# Access Compliance Report

## Public Rights-of-Way

Intersection ID: 32302	Main Street: HAZELVIEW_DR	Cross Street: HONEYNUT_DR	Location:	NW
ADA ID: B42162DD6465	Ramp Type: PerpDiag	Initial Pass/Fail: Fail	Overall Compliance: No	Severity Score: 25
Codes/Mitigation Info/Possible Solution		Field Measurements/Component Compliance

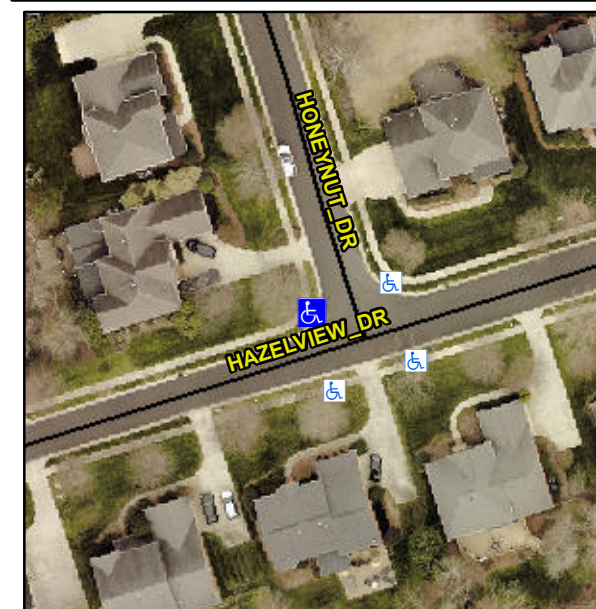
**Not Found, R304.5.3**

Compliance	Description	Data	Compliance	Description	Data
N/A	Ramp Length (in)	50.0	Yes	Ramp Slope (%)	5.3
Yes	Ramp Width (in)	48.0	No	Ramp XSlope (%)	7.1
N/A	Flare Type LT	N/A	N/A	Flare Type RT	N/A
N/A	Flare Slope LT (%)	N/A	N/A	Flare Slope RT (%)	N/A
N/A	Flare Traversable LT?	N/A	N/A	Flare Traversable RT?	N/A
N/A	Landing Length (in)	N/A	N/A	DWS Provided?	N/A
N/A	Landing Width (in)	N/A	N/A	DWS Contrast?	N/A
N/A	Landing Slope (%)	N/A	N/A	DWS Length (in)	N/A
N/A	Landing X Slope (%)	N/A	N/A	DWS Full Width?	N/A
N/A	Landing Curb? (Y/N)	N/A	N/A	DWS Offset (in)	N/A
N/A	Shared Landing?	N/A			
N/A	Gutter Ponding?	N/A	N/A	Gutter Slope (%)	N/A
N/A	Gutter Lip Ht (in)	N/A	N/A	Gutter X Slope (%)	N/A
N/A	Painted X Walk1?	No	N/A	Painted X Walk2?	No
	X Walk 1 Direction	To S		X Walk 2 Direction	To E
N/A	X Walk 1 Width (in)	N/A	N/A	X Walk 2 Width (in)	N/A
	X Walk 1 Slope (%)	1.5		X Walk 2 Slope (%)	6.0
	X Walk 1 X Slope (%)	6.5		X Walk 2 X Slope (%)	0.5

**Remove & Replace Curb Ramp With Two New Directional Ramps or Equivalent.**
